TITLE: DEPLOYABLE TRUSS HAVING SECOND ORDER
AUGMENTATION

Serial No.: 10/734,726

ANNOTATED SHEET SHOWING CHANGES

FIG. 6A

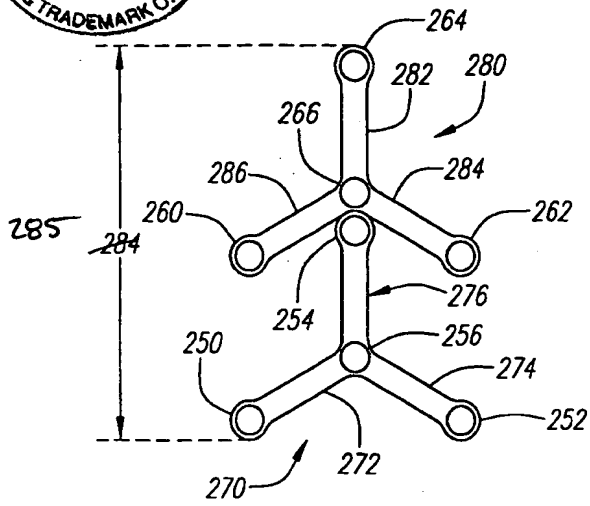
The attached sheets of drawings include changes to FIGS. 6A, 9D and 11B. These sheets, which include FIGS. 6A-6D, 7; 9A-9F; and 10A-10C, 11A and 11B, replace all previous drawing sheets submitted for these figures. In FIG. 6A, distance line "284" has been changed to --285--; FIG. 9D has been revised to change reference numeral 494 (second occurrence) to 496; and FIG. 11B has been revised to change reference numerals 596 (four occurrences) to 597 and reference numeral 594 (second occurrence) to 596. (See attached Replacement Sheet(s) and Annotated Sheet(s) Showing Changes.)
